Agenda item 4.1 (c)

SSC 750- AMS-I.C: Thermal energy production with or without electricity

CDM EB 105

Project Activity Scenario

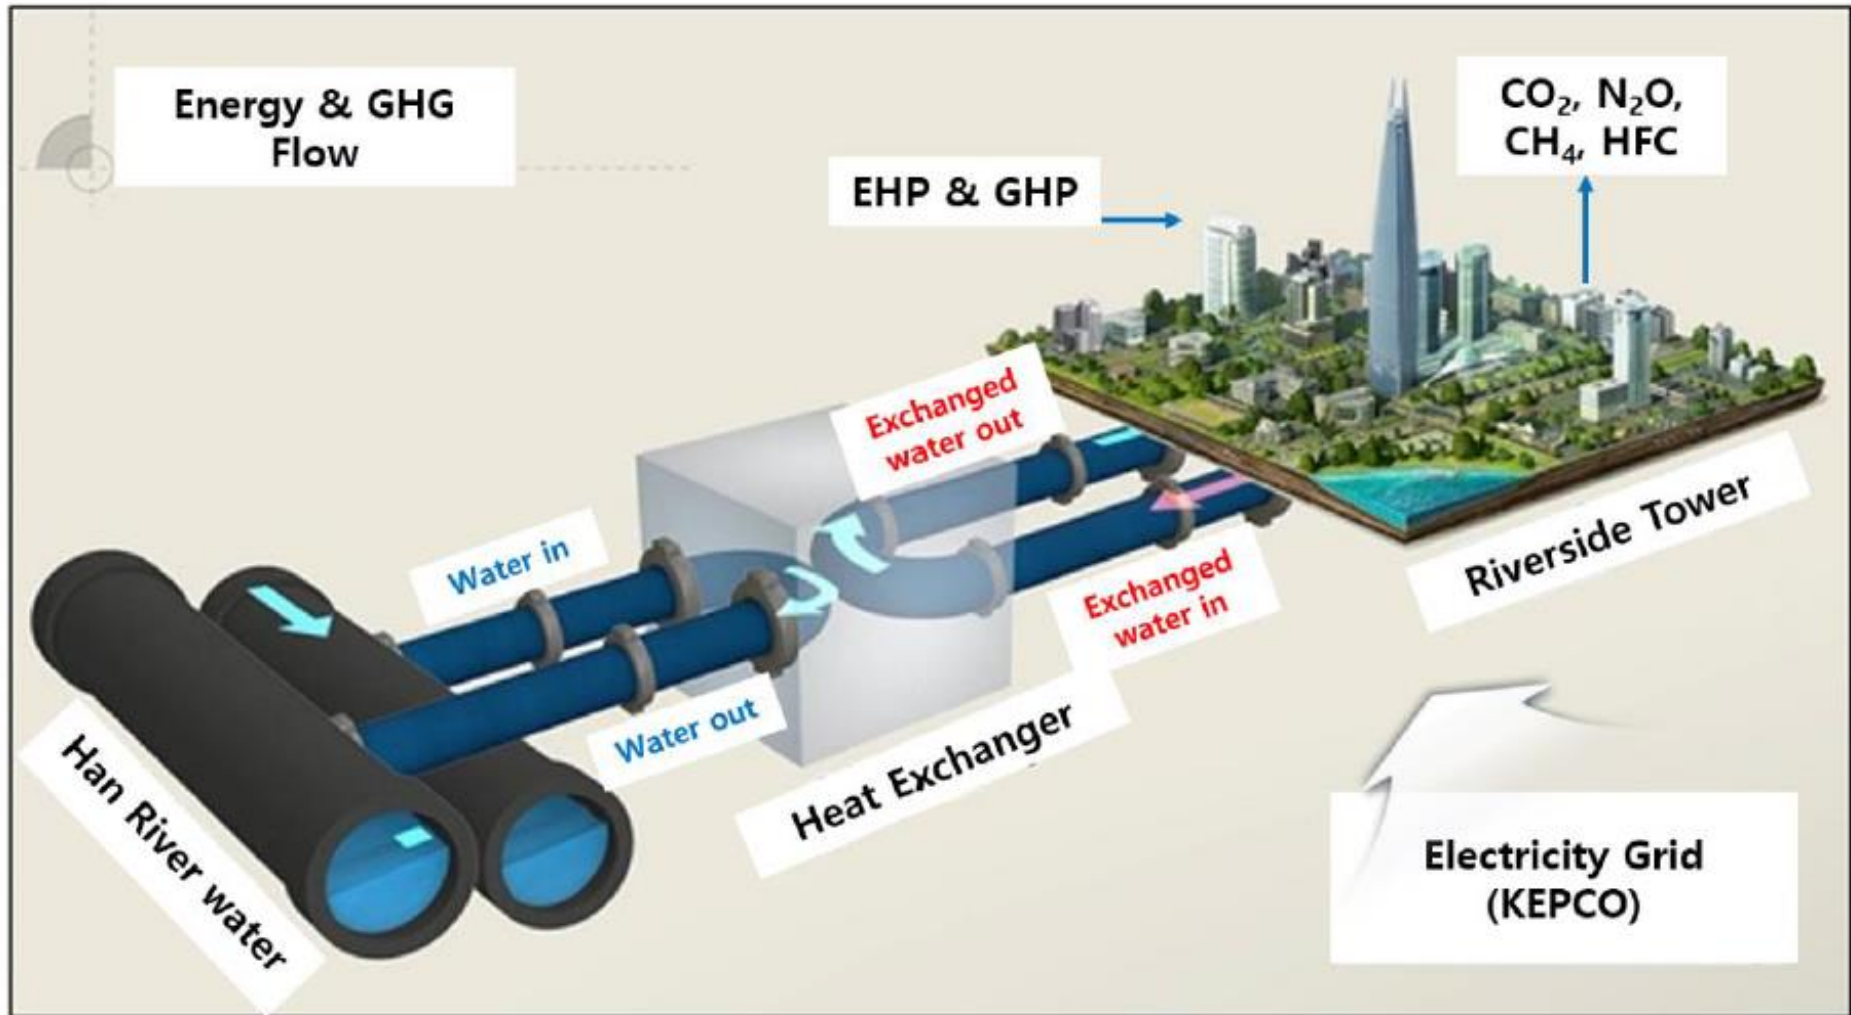
- Capacity of heat pump was excluded from determination of eligible capacity (i.e. 45 MW thermal for type I) for SSC projects
 - PP contends that heat pump included in the boundary for monitoring but excluded for eligible capacity determination only

- The calculations of emissions from the use of refrigerants in the baseline and project scenarios are more appropriately accounted for in Type III Methodologies rather than in a Type I methodology.

- PP contends refrigerant emissions are adequately covered in their submission
- Lastly, the impact of the proposed eight additional (potential) scenarios on the other requirements of the methodology (such as in the monitoring section, emission reduction calculations) were not assessed and included in the proposed request.

- PP contends that the eight baseline scenario activities result in electricity and fossil fuel consumption and/or refrigerant use

- The MP recommended that the Board not accept the revision request “SSC_750: Revision of AMS-I.C for the project to use the river water thermal energy with heat pump or heat exchanger”.
- PP has the discretion to make a new submission for a new methodology or for a revised methodology
